## Product Change Notification: ALAN-10KOZF594

CCB 7276 Initial Notice: Qualification palladium coated copper with gold flash (CuPdAu) as a new bond wire material for selected MCP3421, MCP4725, MCP4726, MCP4706, MCP4716, MCP9510, MCP47DA1, MCP4023, MCP4022, MCP4013, MCP4012, and MCP3425 device families available in 6L SOT-23 package.

## Pre and Post Change Summary

### PCN# ALAN-10KOZF594

# Pre and Post Change Summary

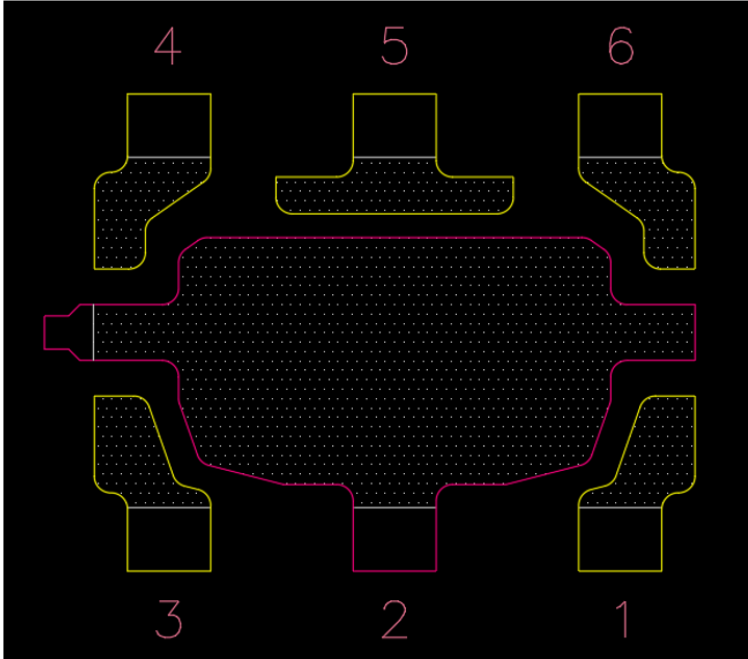
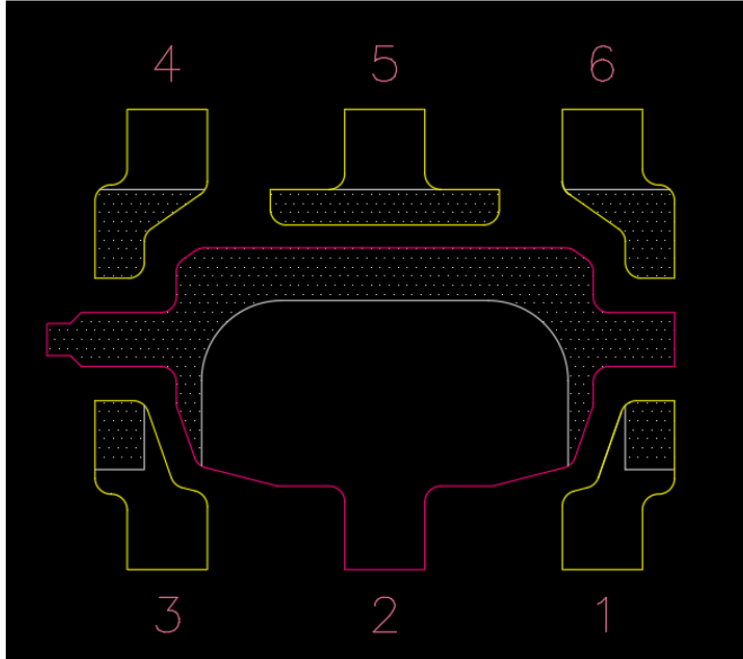
Lead-Frame Material	CDA194	Lead-Frame Material	A194
DAP Surface Prep	Ag Spot Plated	DAP Surface Prep	Ag single ring Plated

Note: C194, A194, or CDA194 Lead-frame material are the same, it is just a MCHP internal labelling difference.
